MORNING THORPE SUBDIVISION
OXFORD, CONNECTICUT

KING'S MARK
ENVIRONMENTAL REVIEW TEAM REPORT
on the
MORNING THORPE SUBDIVISION
OXFORD, CONNECTICUT
DECEMBER 1976

The King's Mark Environmental Review Team was asked to review approximately 154 acres of land for which is proposed a 70 lot single-family home subdivision. The property is located just east of Route 188 and north of Hogsback Road in an area of west central Oxford known locally as Quaker Farms.

TOPOGRAPHIC MAP

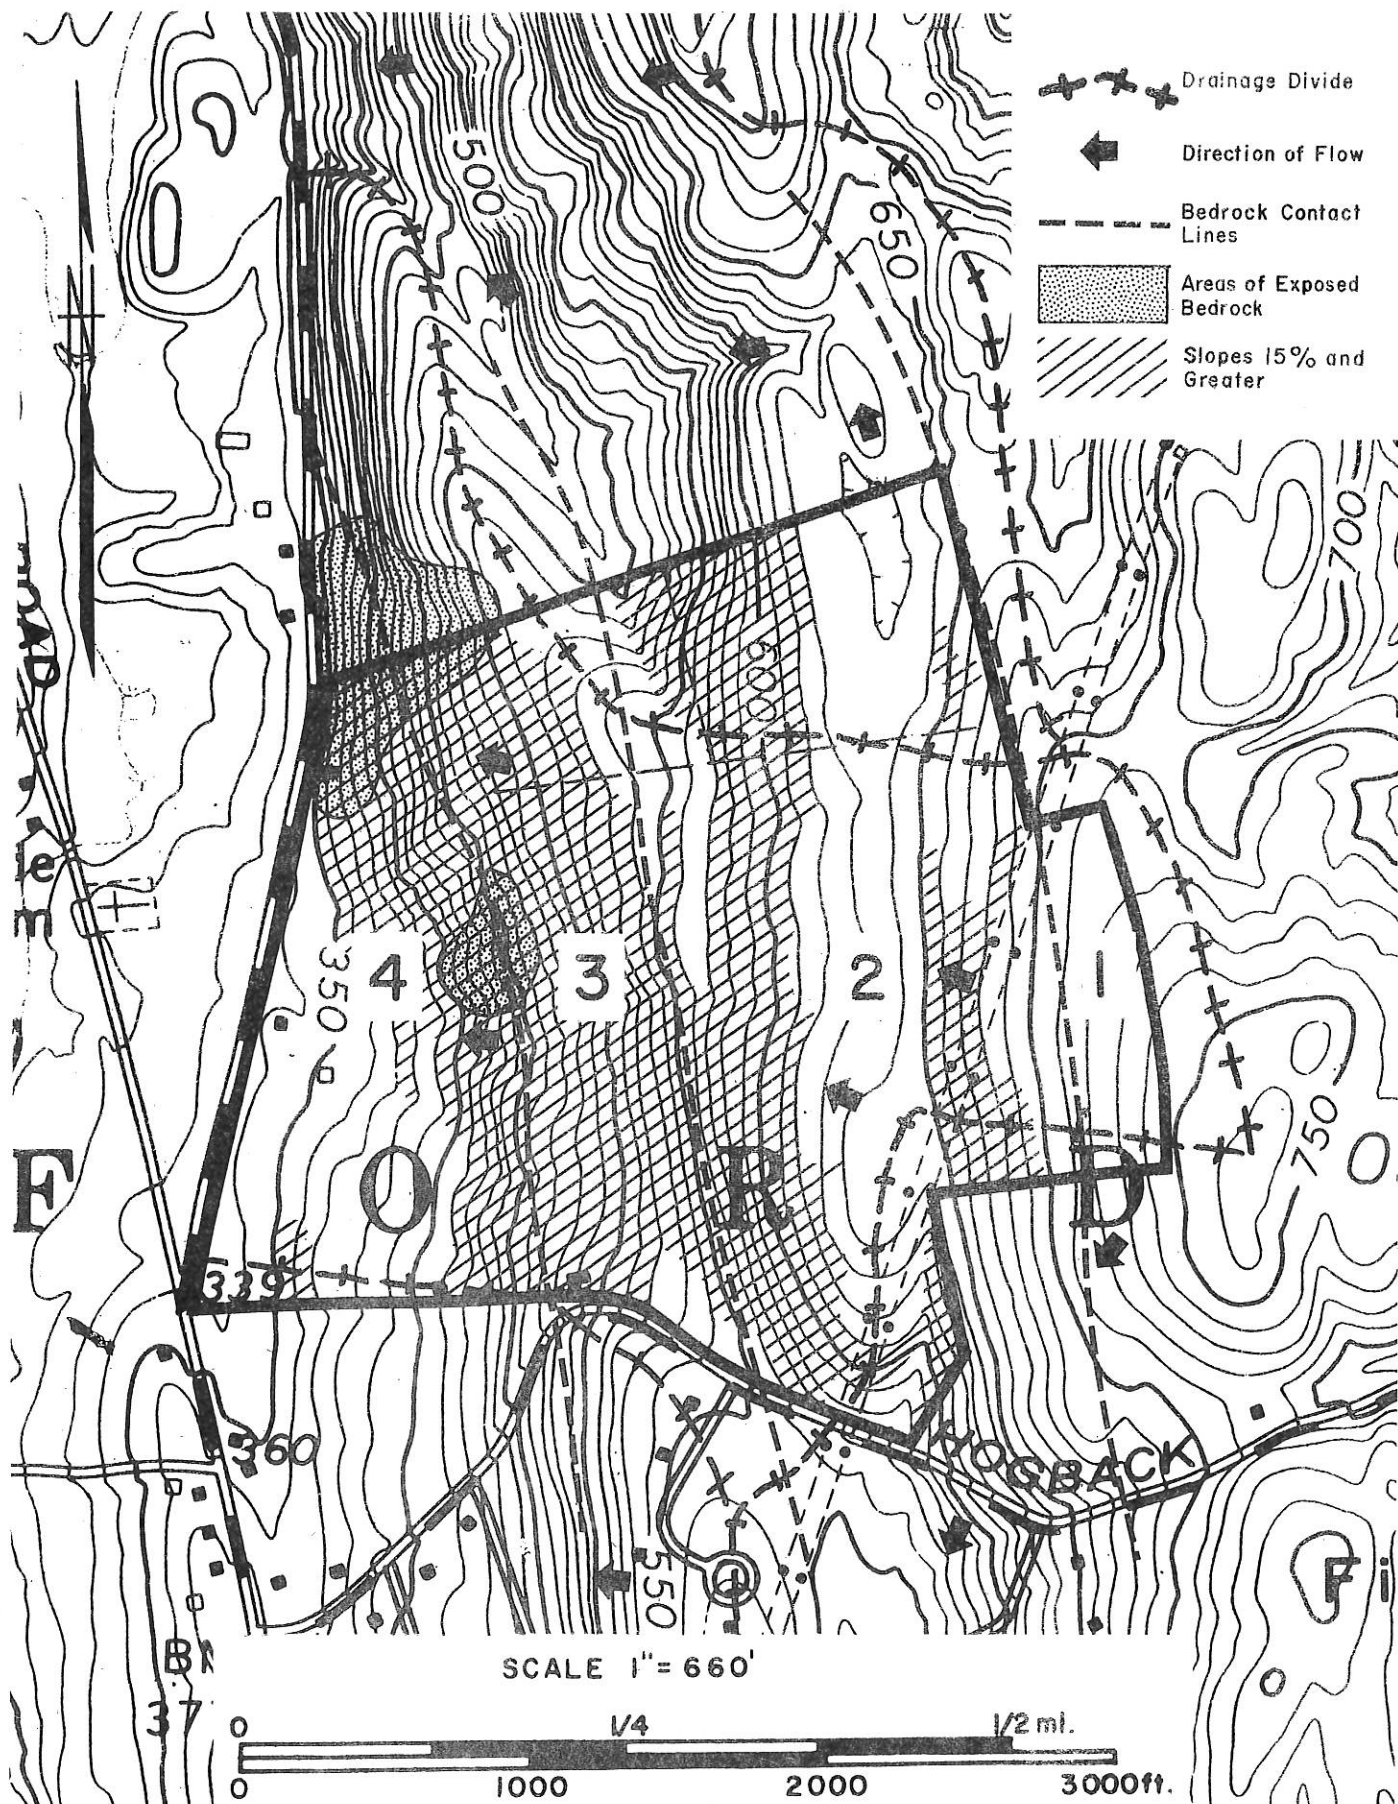
The Morning Thorpe property crosses four distinctly recognizable classifications of bedrock. All are metamorphic schists or gneisses or some variation or combination of both. The Topographic Map roughly outlines and enumerates their boundaries. (The "bedrock contact lines" indicate where the different bedrock units meet.) A schist is a rock that has formed under intense heat and pressure causing the micaceous mineral components to orient in a sub-parallel direction resulting in a layered appearance. Gneisses are more coarse grained banded rocks in which the granular minerals form layers that alternate with layers of schistose or dark flat minerals.

When man accelerates water movement through these delicate areas by disrupting and paving over the land surface, the risk of dangerous situations developing increases. It would appear only two locations on this property may have the potential for this type of problem; these are in those areas delineated as bedrock exposures on the Topographic Map.

SOIL MAP

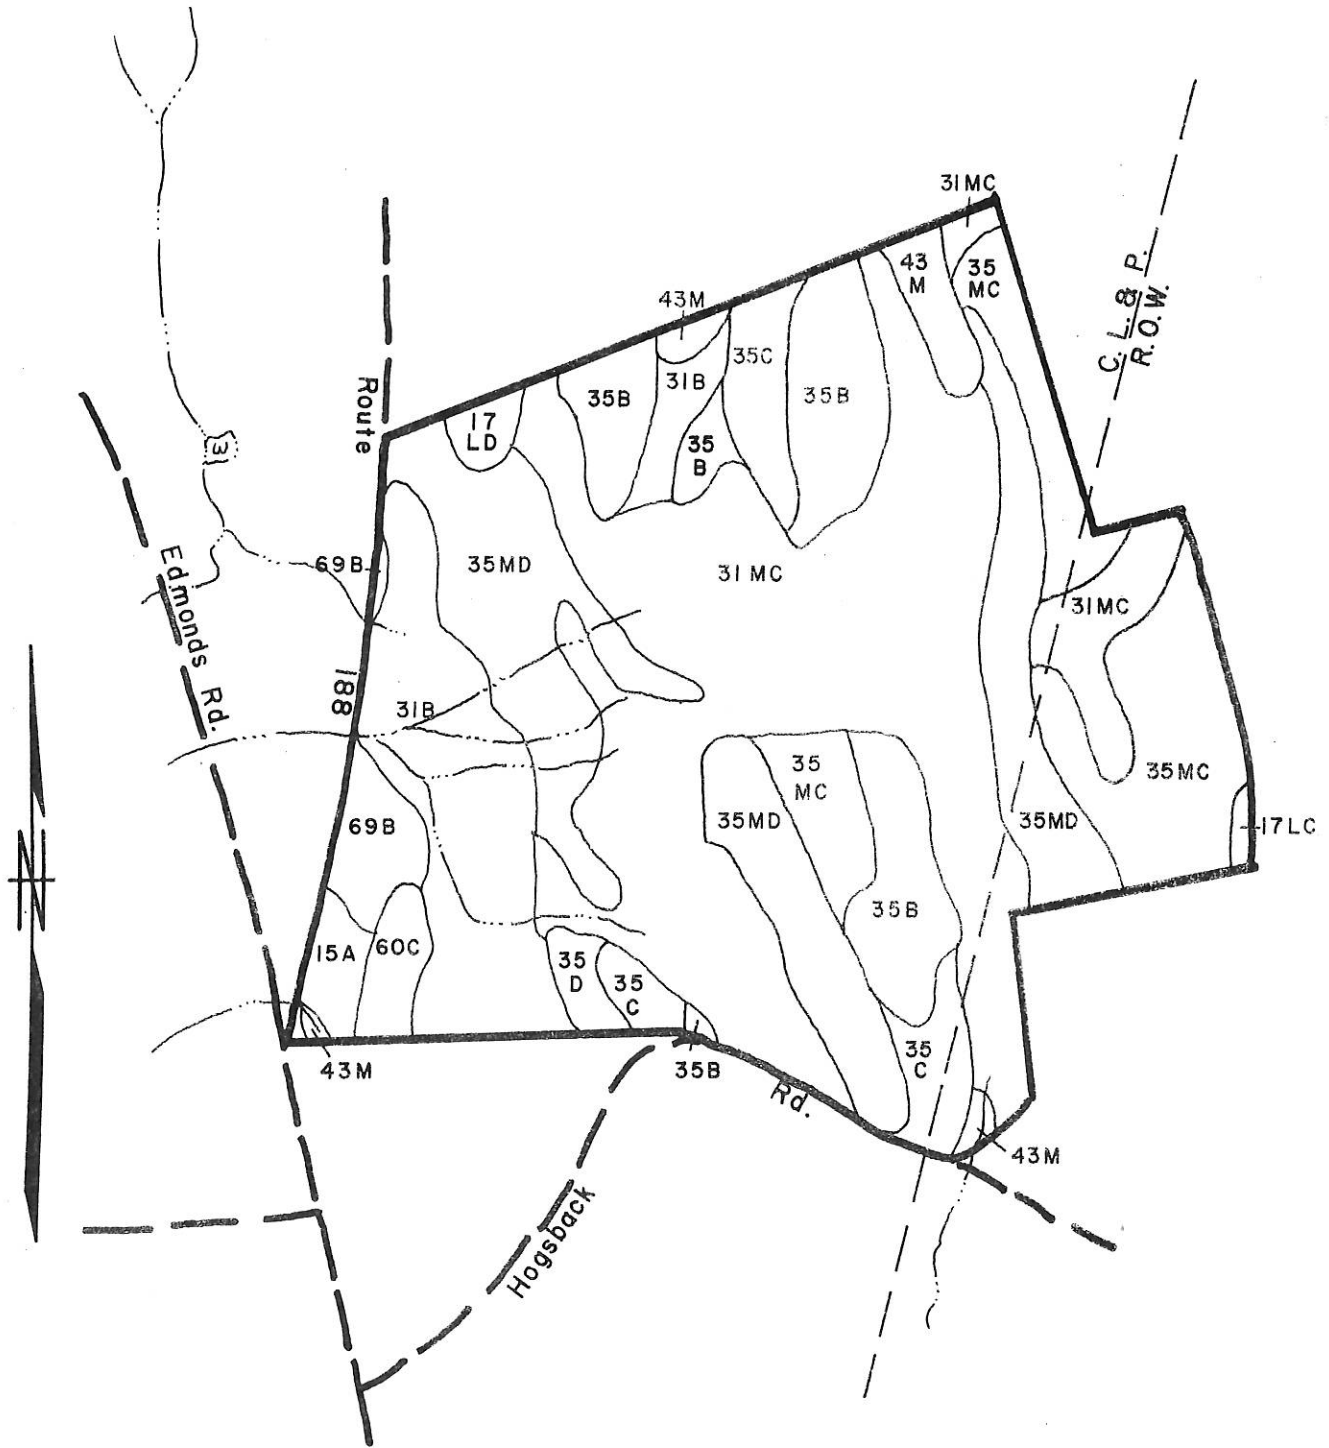
As shown on the Soils Limitations Chart, many of the soils on the site are rated as having severe limitations for urban uses. The site presents severe development problems due primarily to steep slopes and hardpan soil conditions with perched water tables. There are extensive areas of moderately well drained soils with seasonal water tables being within 16 to 18 inches of the land surface. This would cause severe limitations for the development of on-site sewage disposal systems, homesites with basements, homesite landscaping, and streets and parking lots. Extensive subsurface drainage systems will have to be described on the subdivision plan to demonstrate:

1. how the on-site sewage disposal systems will be protected from drowning out,
2. how basements will be protected against flooding,
3. how streets and parking areas will be relieved of the hydrostatic pressure developed on these soils which will cause streets to crack, freeze and heave during the fall, winter and spring months, and
4. how road bank cuts will be protected from bleeding water during these months.

In view of the above drainage problems: street drains will need to be slotted pipe to pick up subsurface water, driveways may need tile drainage (particularly those on the downslope side of streets) and homesites with basements will probably need foundation drains installed around footings. Drains should outlet into a storm drainage system or natural drainageway.

There are many seepage areas on the site that develop small minor inland wetlands that could cause serious problems concerned with all of the above mentioned problems. These areas need further investigation and evaluation by the Town of Oxford's Inland Wetlands Commission.
